ADDENDUM NO. 3

Project Name: **Olmos Basin Central Watershed Sewer Relief Line (C-3), Reaches 1 to 4**

Project No.: **08-2512**

Solicitation No.: **B-11-051-CM**

SHEET NO. **C-110**
39 OF 123

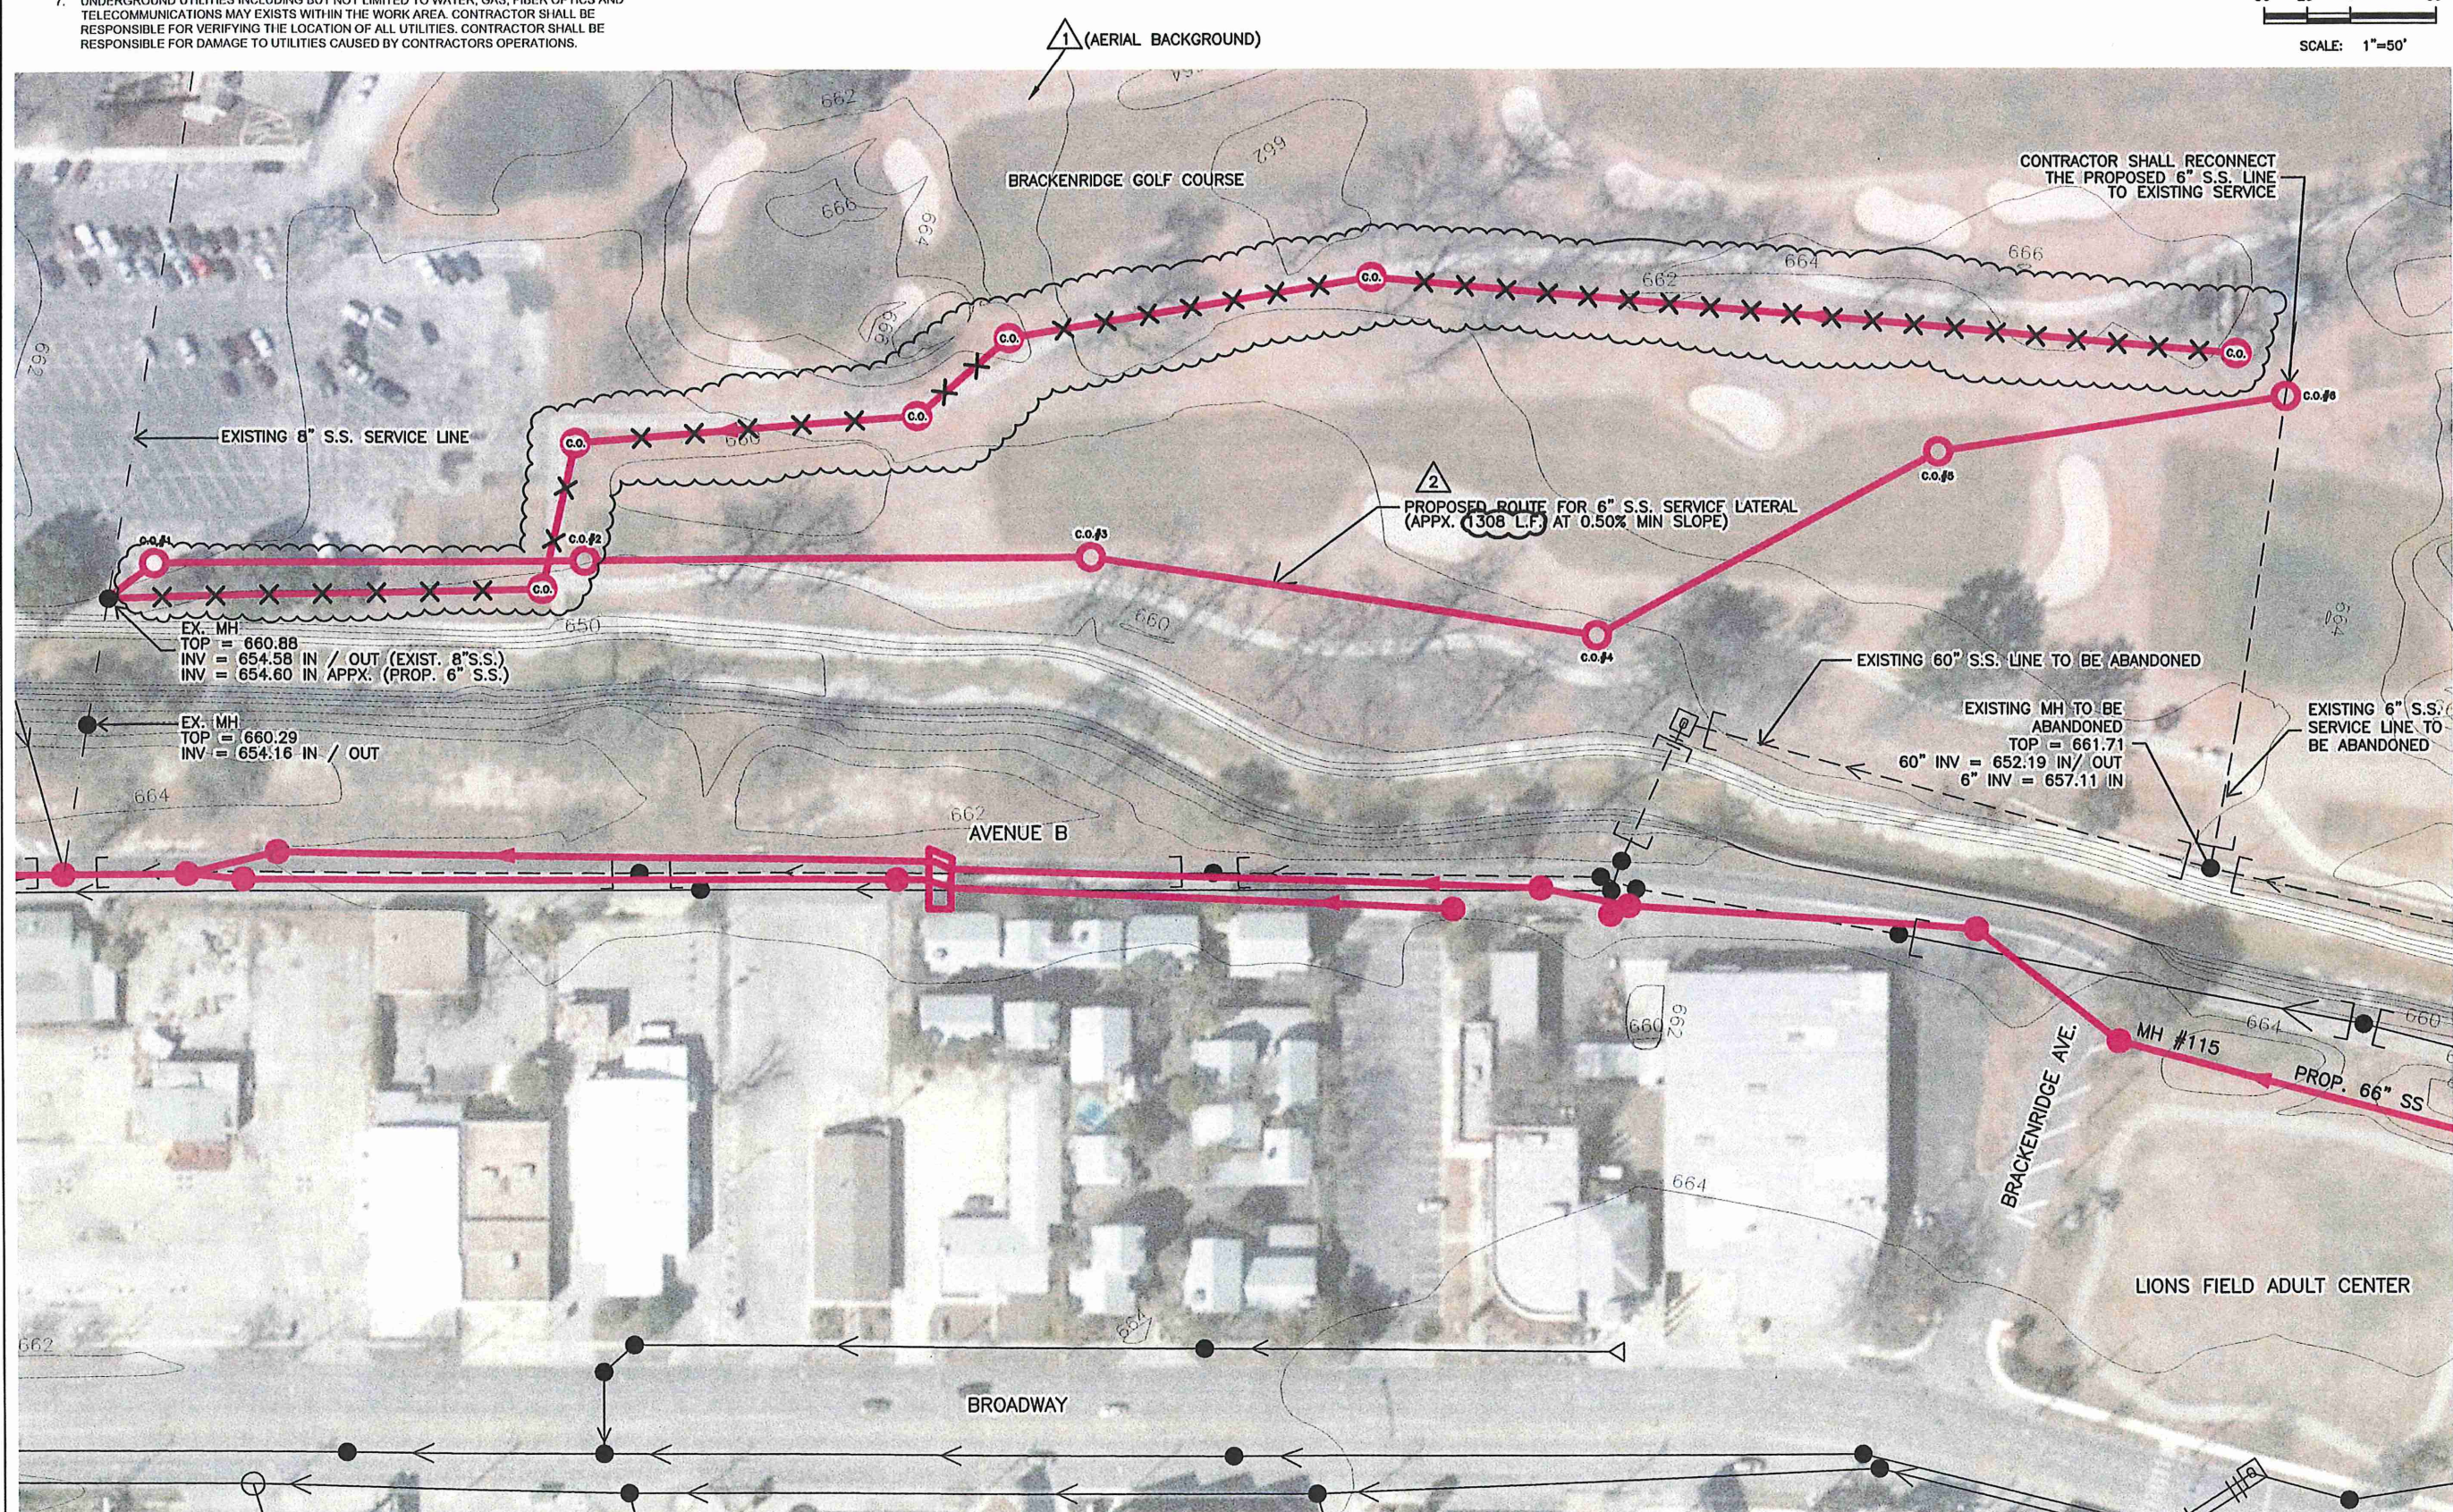
Item 1: Sheet C-110 – Remove and replace Sheet C-110 with the revised Sheet C-110 attached to this addendum. Revisions include:

- a) Aerial background has been updated. Note the newer aerial shows recent improvements at the golf course.
b) Alignment of proposed lateral reroute was adjusted as shown on Revised Sheet C-110.
